**Town of Surfside
DESIGN REVIEW BOARD/
PLANNING & ZONING BOARD
AGENDA**

May 31, 2018 – 6:00 p.m.

A. 8995 Collins Avenue - Site Plan; Conditional Use for Hotel Pool and Alternative Parking System; Variances for Landscaping and Loading Space Size

Subject: 8995 Collins Avenue
From: Guillermo Olmedillo, Town Manager
 Sarah Sinatra Gould, AICP, Town Planner

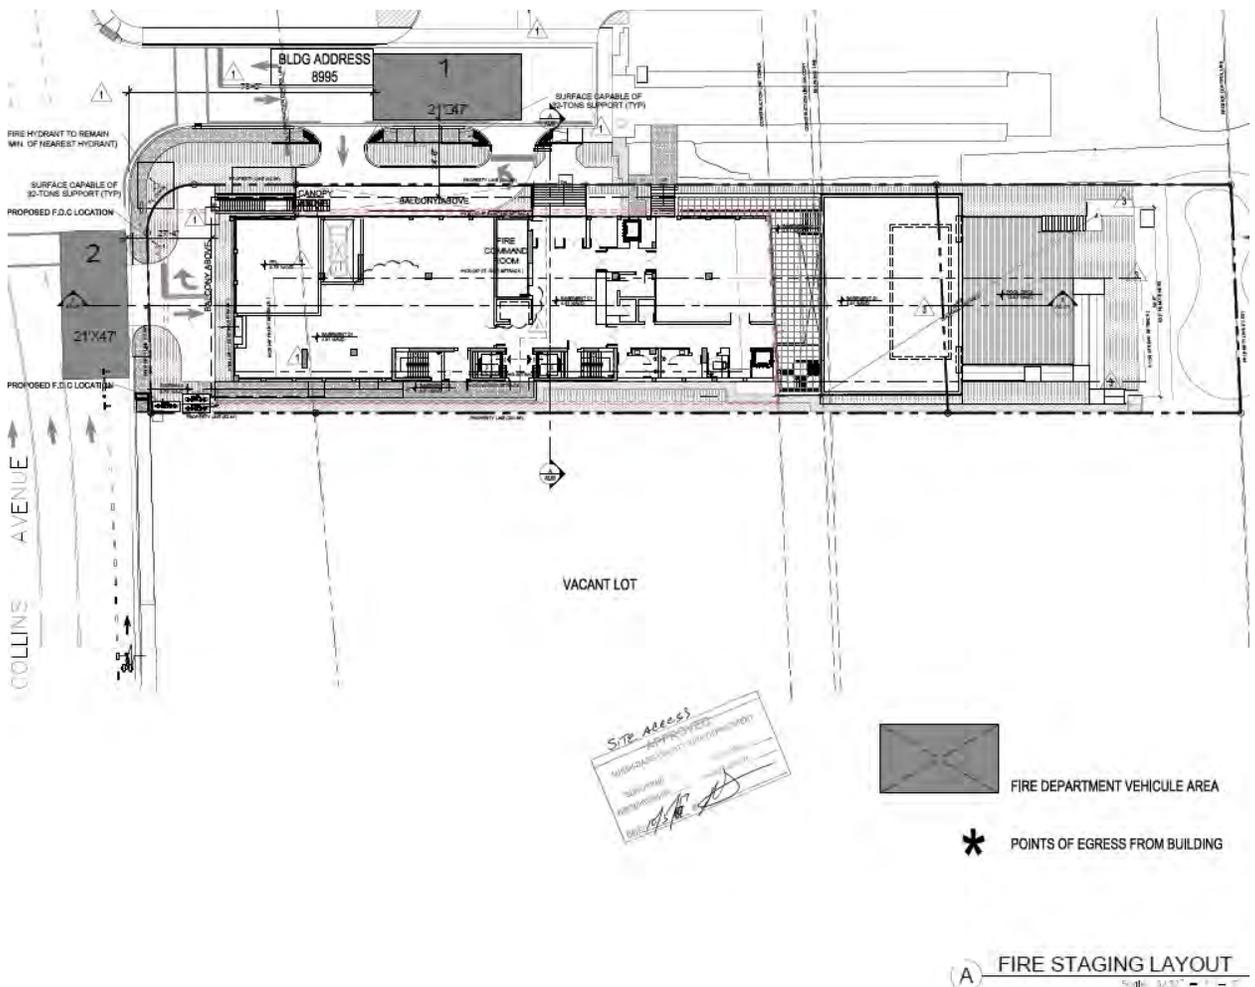
- Please either label the directional arrows that are shown on the pavement marking and signage plan as "informational only" or remove the symbols from the plans. It is unclear from the design plans if these are to be installed as part of the project.

Ocean Engineering, Inc. 04/23/18 Response: *the directional arrows have been removed from the pavement marking and signage plan. (WL)*

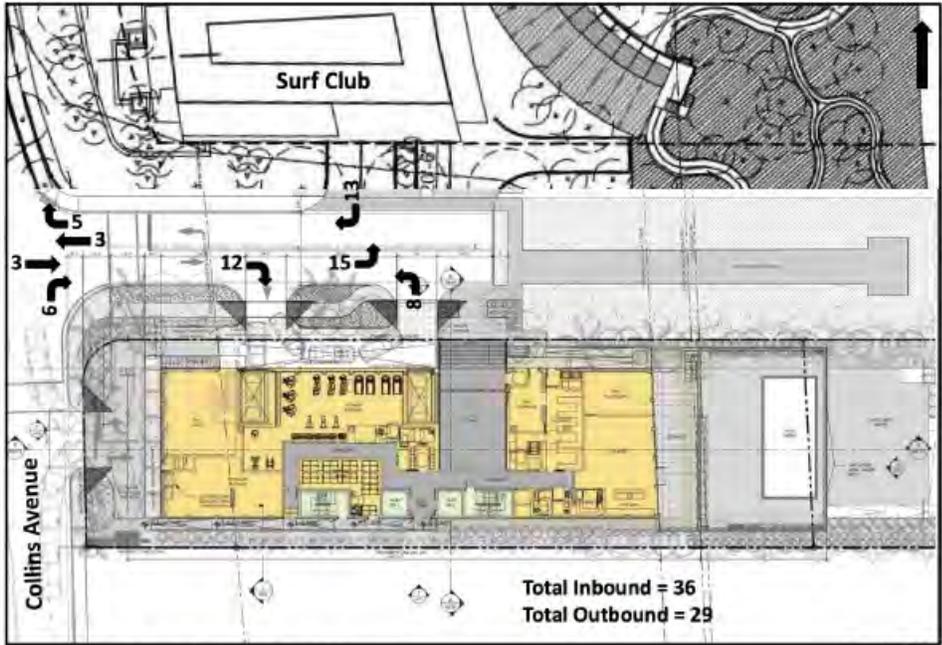
- One hour is far too long to be an appropriate analysis interval. The result of this type of analysis is sensitive to the choice of analysis "interval" length. For any sufficiently short interval the most likely number of arrivals is zero and there is of course no chance of any queue. In undersaturated conditions like this, given a sufficiently long analysis interval, any queue buildups within the interval due to the variable arrival rate involved are inevitably discharged.

Tom Hall 04/23/18 Response: *While the reviewer may believe an hour to be too long an interval for estimating queues for the project, that is the method prescribed in the Institute of Transportation Engineer's Transportation and Land Development manual. In an effort to think through another method for considering the random arrival of vehicles to form a queue of entering vehicles, it occurred to us that Simtraffic could provide such an estimate. As a microscopic simulation model, it looks at every vehicle on a random arrival basis.*

CONFLICT POINTS DIAGRAM

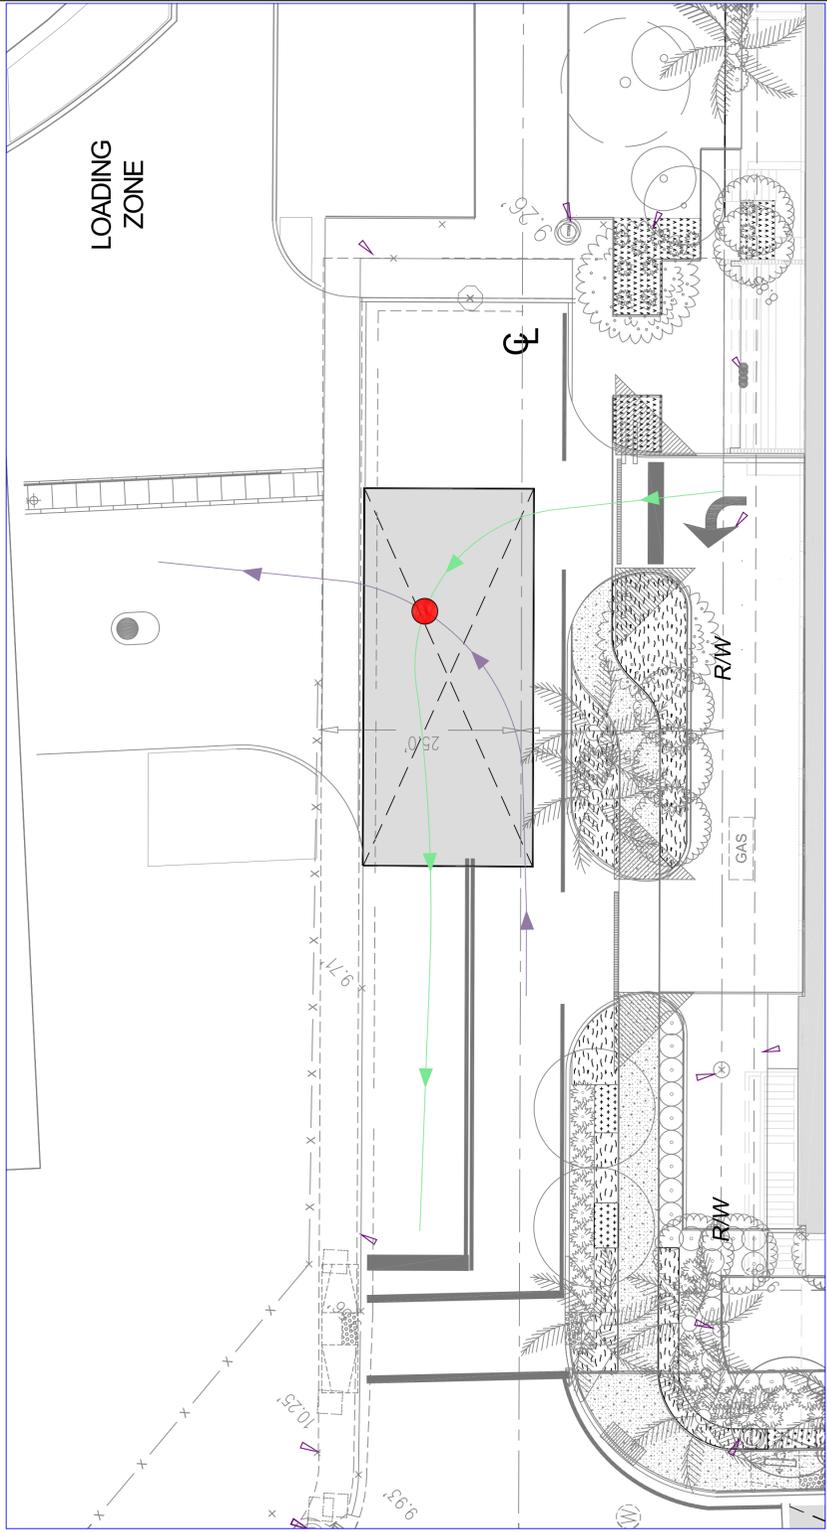
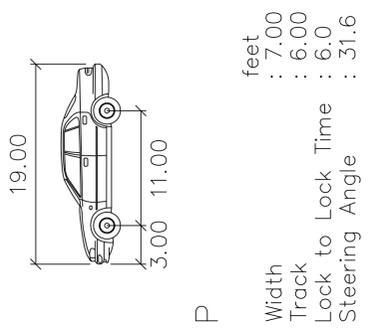
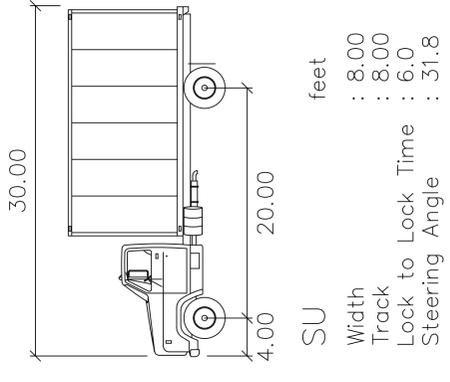
To demonstrate the concerns, staff prepared the attached Conflict Point Drawing which shows the number of conflicts that could potentially occur within the 90th Street public right of way. Subsets of the overall Conflict Point Drawing were created that show all of the individual movements. This graphic also includes the Fire Rescue laddering area.
